DOCUMENT CHANGE REQUEST

DCR number 634	Changes required for: N/A	Originator: Samuel SAVIN
Date: 2011/06/16	Date sent: 2010/11/23	Organisation: CNES
Status: IMPLEMENTED

Title:	Diodes Silicon Switching, based on types 1N6639, 1N6640 and 1N6641		
Number:	5101/027	Issue:	1

ESCC Detail Specification No. 5101/027

FIGURE 1 – PARAMETER DERATING INFORMATION (Not Applicable for the variants 07 to 08)

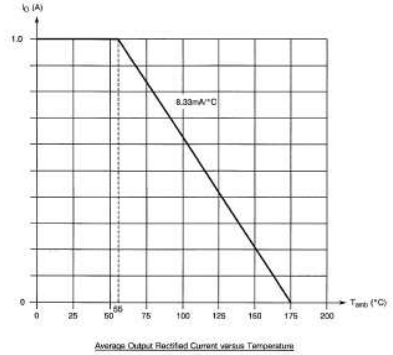
b) Removal of any redundant paragraphs and information,
e.g.: Figure 1; mechanical paragraph; Figures 4, 5(a), 5(b); Appendix A for MICROSEMI/I

Figure 2(c)- Variant 07 to 08 - Leadless Chip Carrier 2 (LCC2D) – 2 Terminal

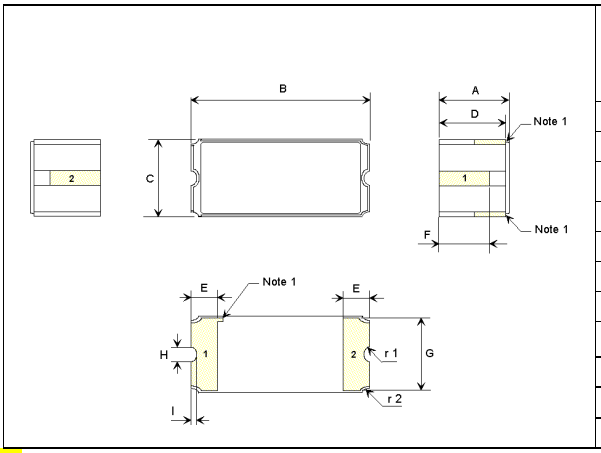
Justification .
Variant 07: new ST variant introduction with LCC2D package
Variant 08: new ST variant introduction with LCC2D package

Ref	Dimensions					
	Millimeters			Inches		
	Min	Typ	Max	Min	Typ	Max
A	1.86	2.03	2.20	.073	.080	.087
B	4.44	4.57	4.77	.175	.180	.188
C	1.84	1.97	2.10	.072	.078	.083
D	1.53	1.7	1.87	.060	.067	.074
E	0.48		0.71	.019		.028
F	1.3			.051		
G	1.67			.066		
H	0.37			.015		
I	0.15			.006		
r1	0.15			.006		
r2	0.20			.008

Notes:
1- The anode is identified by a metallization in 2 top angle castellations and by the index mark on the bottom metallization n° 1.
2- Measurement prior to solder coating the mounting pads on bottom of package.
